RECEIPT DATE: 7/17/17 ONSITE SEWAGE DISPOSAL SYSTEM P 561464
APPROVAL DATE: 7/26/17 (SEO) PERMIT: CONSTRUCTION A
PROPERTY ADDRESS: 2029 Drovers Lane
SUBDIVISION: Vista Ridge LOT: TAX ID:
CONTRACTOR: Fogle's Septic Clean Inc. EMAIL: kim@foglesinc.com
CONTRACTOR ADDRESS: 580 Obrecht Road, Sykesville, MD 21784 PHONE: 410-795-5670
PROPERTY OWNER: DR Horton, Inc. EMAIL:
OWNER ADDRESS: 1356 Beverly Road Suite 300, McLean, VA 22101 PHONE: 571-723-0813
SEPTIC TANK SIZE (GALLONS): 2000 TANK MANUFACTURER: Mayer Bro, Inc.
PUMP MODEL: N/A PUMP SIZE N/A PUMP TANK CAPACITY: N/A

**WALL CHECK
VISTA RIDGE
A RESUBDIVISION OF LOTS 1-4,
CREATING LOTS 5 THRU 21, AND
PRESERVATION PARCELS "A"
THROUGH "D"
PLAT No. 22434
LOT No. 19
2029 DOVERS LANE**

From: Oswald, Hank
Sent: Tuesday, February 07, 2017 9:52 AM
To: John Carney (jcarney@bei-civilengineering.com)
Subject: Septic Plan_Septic Specs
Attachments: Septic specs_2029 Drovers Lane.pdf

OWNER/BUILDER:		PROJECT:	
DR HORTON, INC. 1356 BEVERLY ROAD SUITE 300 MCLEAN, VA 22101 PHONE: 571-723-0813 FAX: 800-551-5015		VISTA RIDGE LOT 19	
LOCATION:		2029 DROVERS LANE COOKSVILLE, MD 21723 TAX MAP No. 8 - BLOCK No. 23 - PARCEL No. 176 4TH ELECTION DISTRICT, HOW

TRENCH/DRAINFIELD DATA		
WIDTH	INLET	BOTTOM
3'	4'	8'
NUMBER OF TRENCHES		4
TOTAL LENGTH		180'
ABSORPTION AREA		540' + SIDEWALL
DISTRIBUTION BOX LEVEL		YES
DISTRIBUTION BOX BAFFLE		YES
DISTRIBUTION BOX PORT		YES

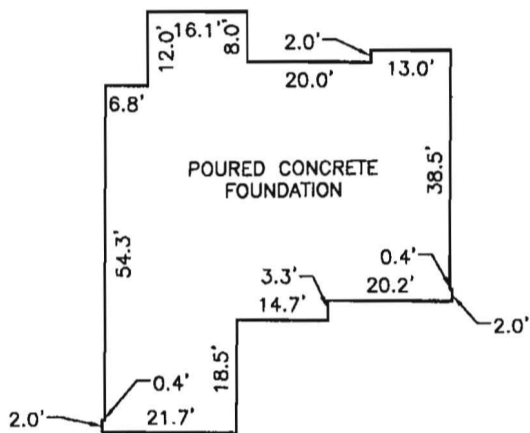
7/21/17 Met Fogle's on site for tank layout. SDA corners staked - flagged tank location as shown on plan. (SC) 7/24/17 Met Fogle's on site for trench layout. SDA corners staked - SE corner of SDA higher than shown on plan, shot contour + laid out 4x45' trenches to use upper part of SDA. OK to drop inlet to 4' to make fall. (SC)

INSTALLATION: 7/25/17 house connection made. On site for setting of tank - no obvious cracks on sides or bottom. (SC) 7/26/17 Trenches installed + left open for inspection. 3' wide, 3.5-4' to stone. Fogle's says last 10' of T4 had lots of rock 3-8'. Levelled speed levelers in D-box. (SC)

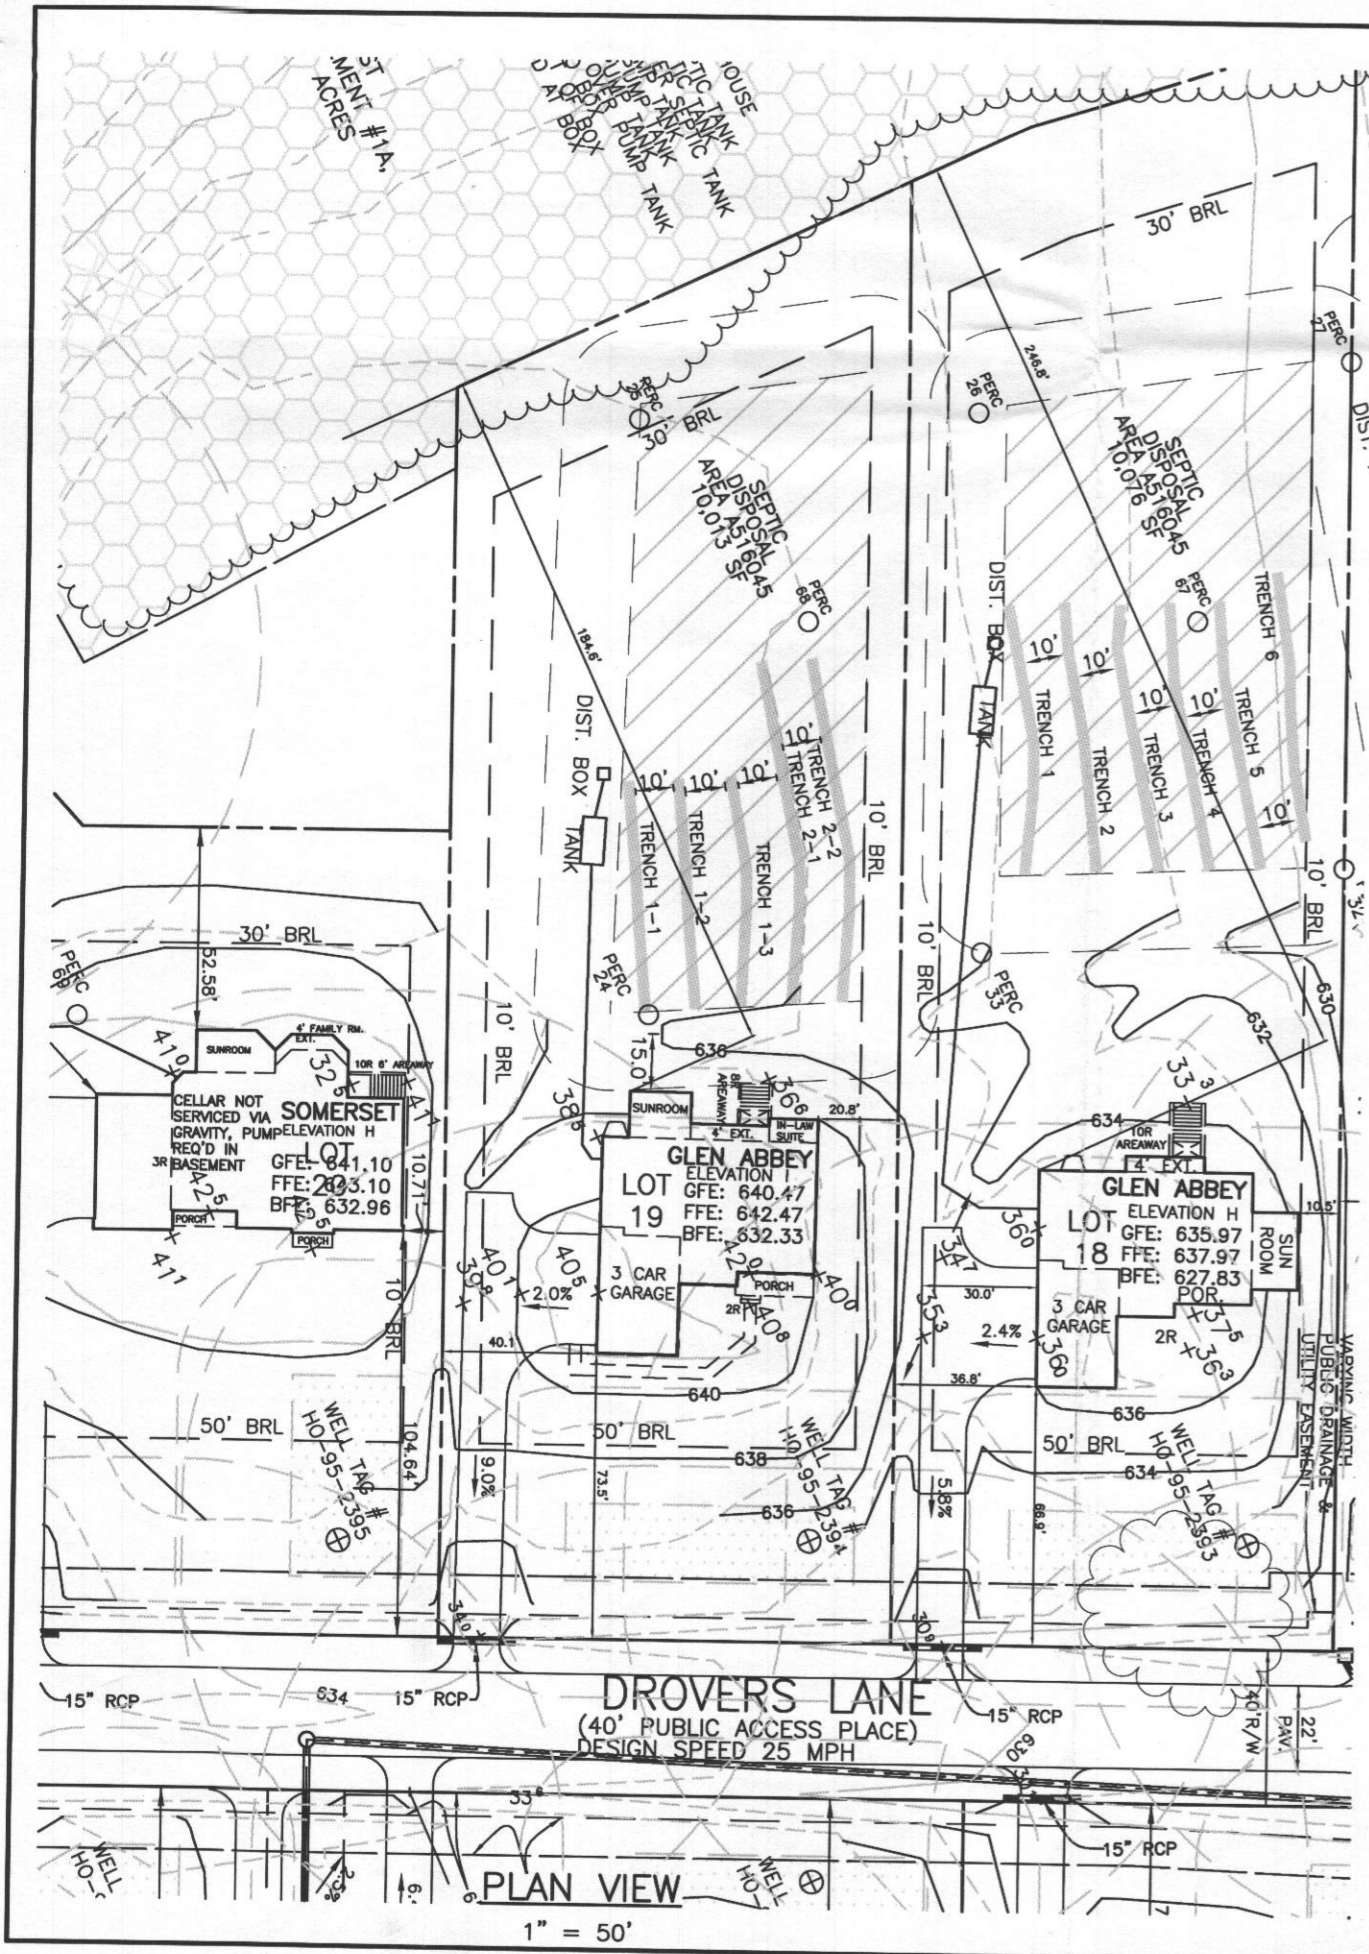
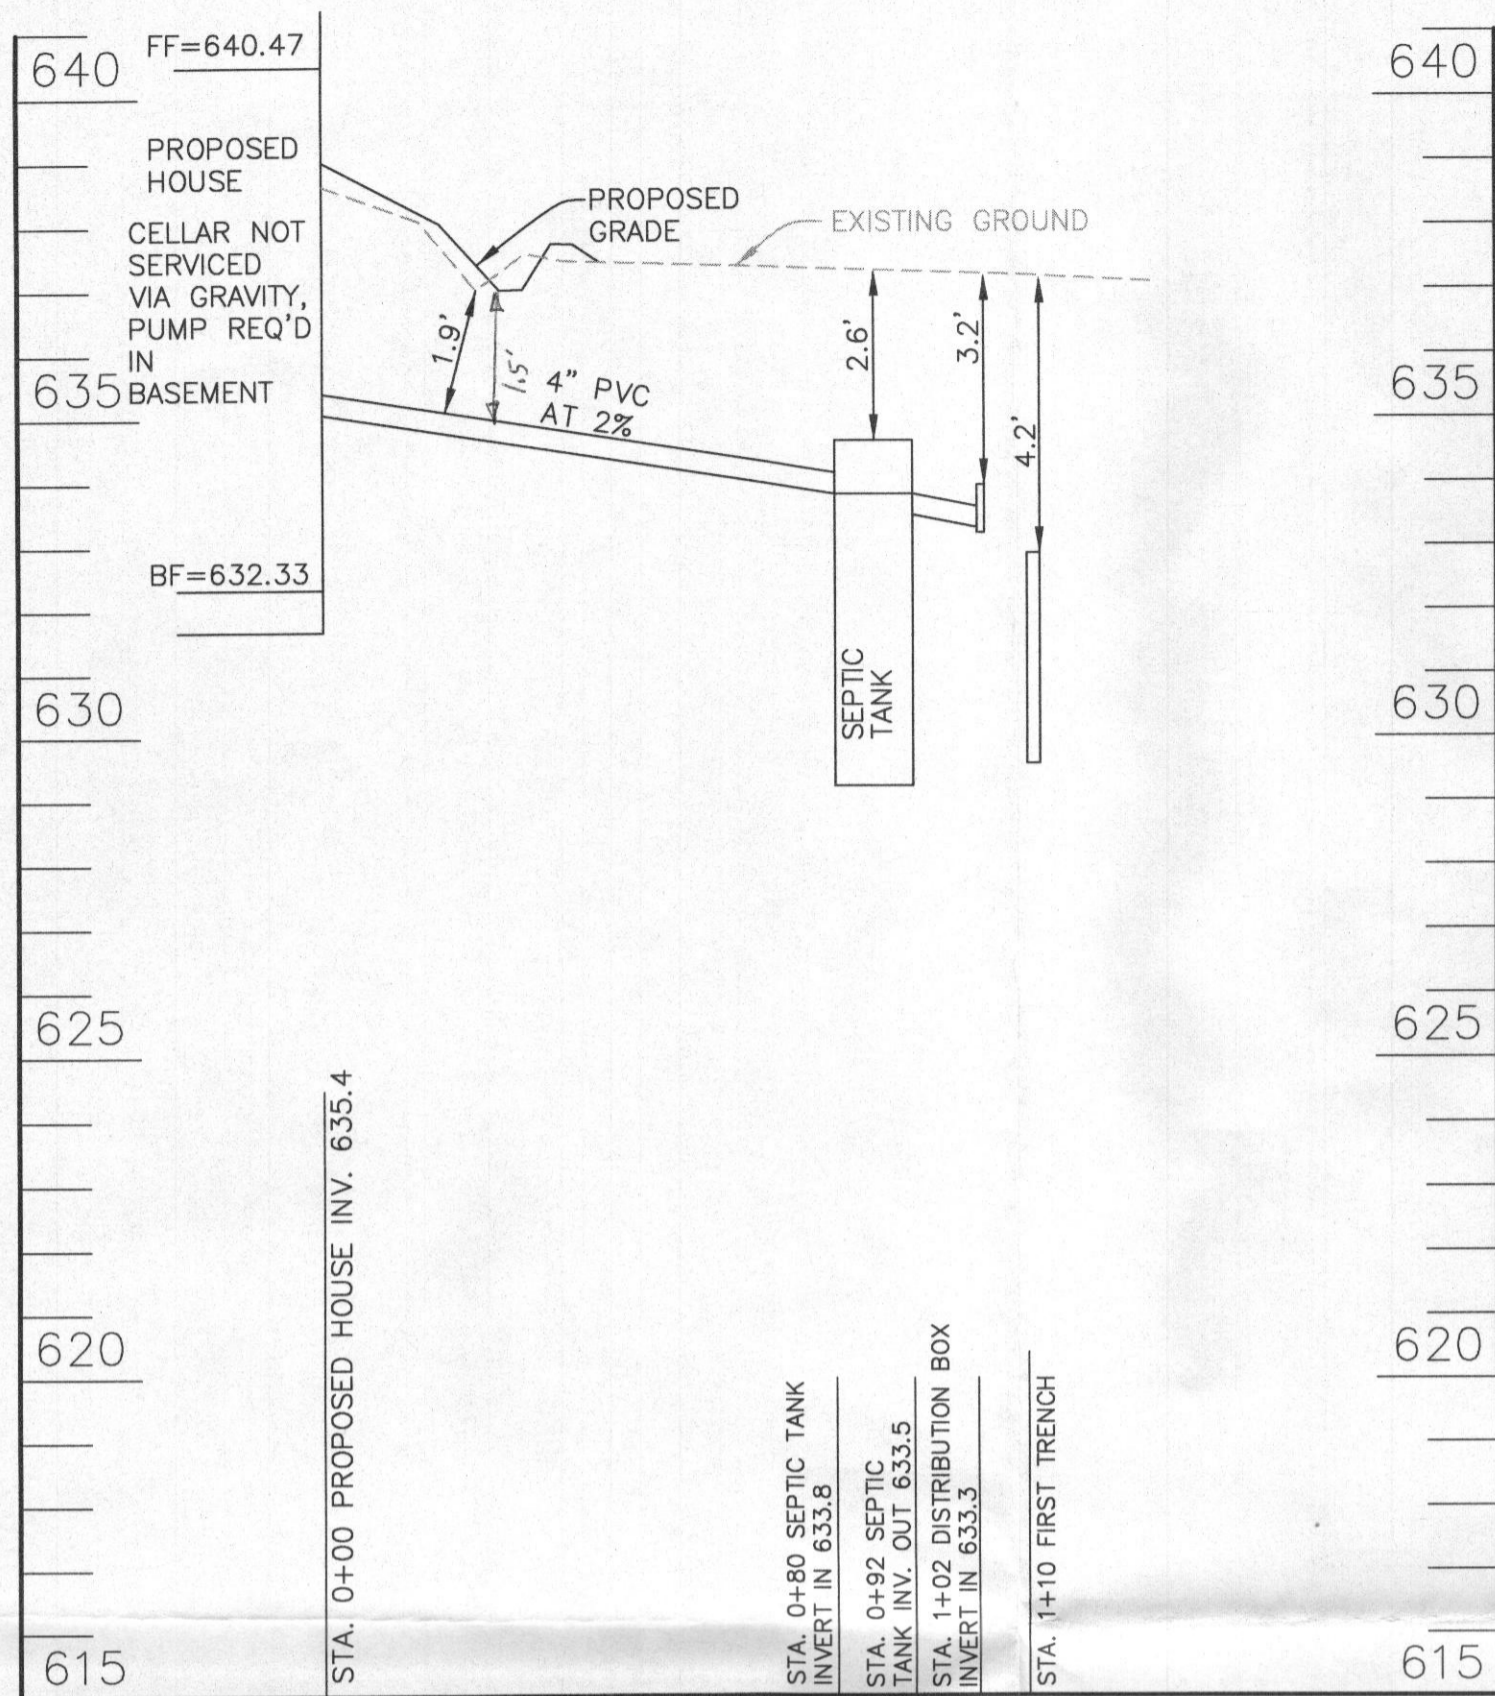
Attached, please find a copy of the septic specs for 2019 Drover Lane (Vista Ridge Lot 19). The specs have been slightly modified to include a little more sidewall. Please revise the OSDS plan to reflect these changes. Also, please include the trench layout for at least the initial and first replacement system on the plan.

REMARKS: I adjusted the trenches and
septic area per the latest specifications
